Control No. 975804A	To: FERMILAB	JTY / KTY Appr.
Last Revision 02	Part no. DO-CAL-PA-V2-C	Drawn By: 10/2/97 R.Bh

SCHEMATIC

Sheet 7 of 9

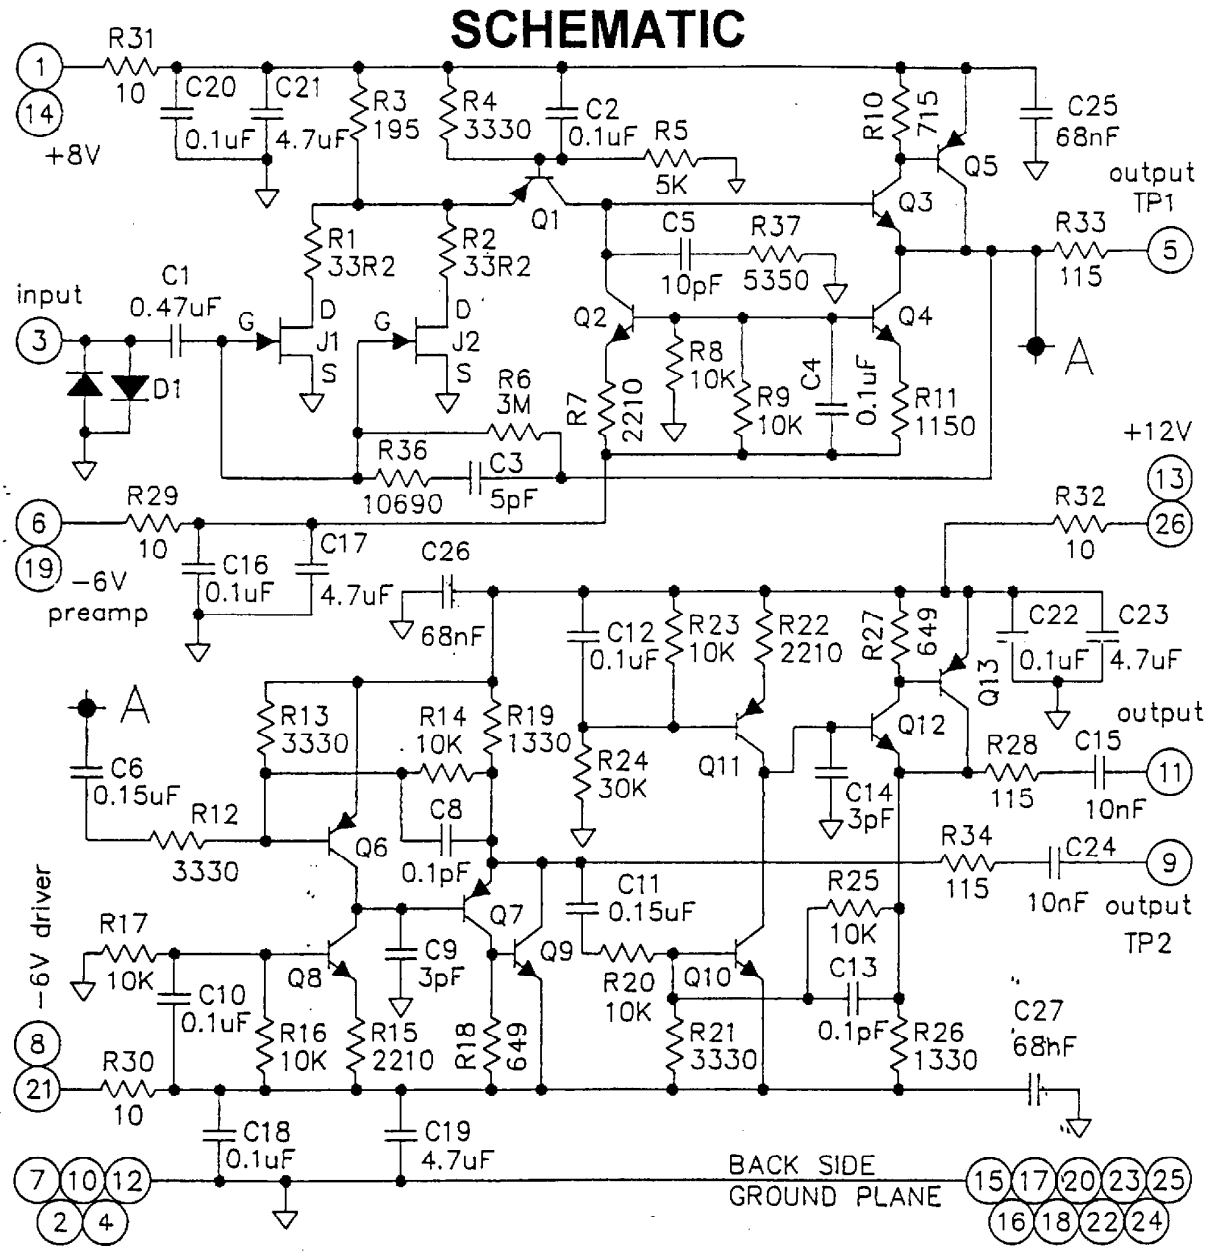
02 Rev. Change R3 from 178 to 195, R36 from 10692 to 10690, and R37 from 5346 to 5350. By / Date LB 6/15/98
